**Addendum #2 - Clarification To
Request for Proposal
For Gateway Theatre Group Phase IV: Project 189-178578**

Bulletin 21 - Addendum 01

WSU: 189-178578

Architectural/Structural

1 SCISSOR LIFT ENLARGED BOH VESTIBULE PLAN

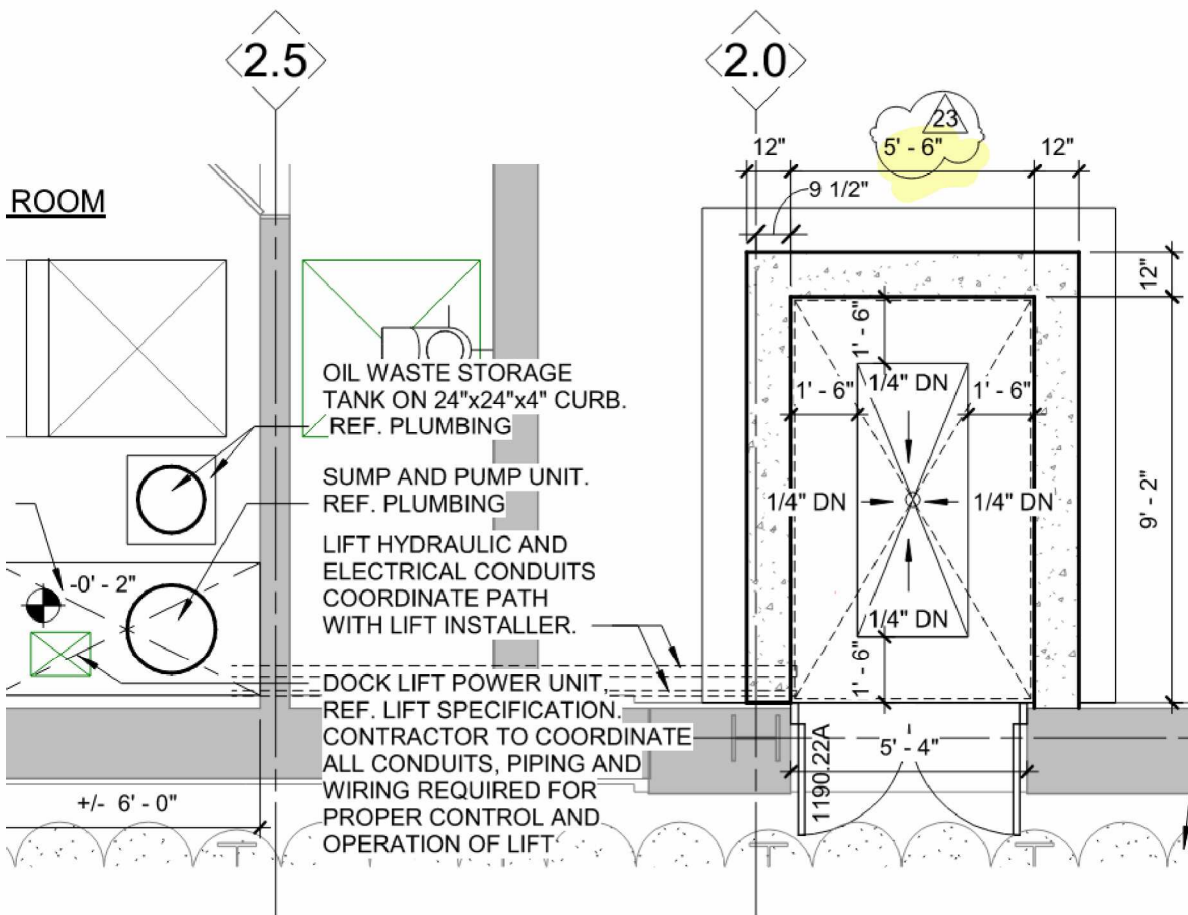
A5.3.3 Pit lift dimensional clarification: Change pit width Clear Dimension from 5'-4" to 5'-6" on Detail 1/A5.3.3, 2/A5.3.3 and 14/A5.3.3
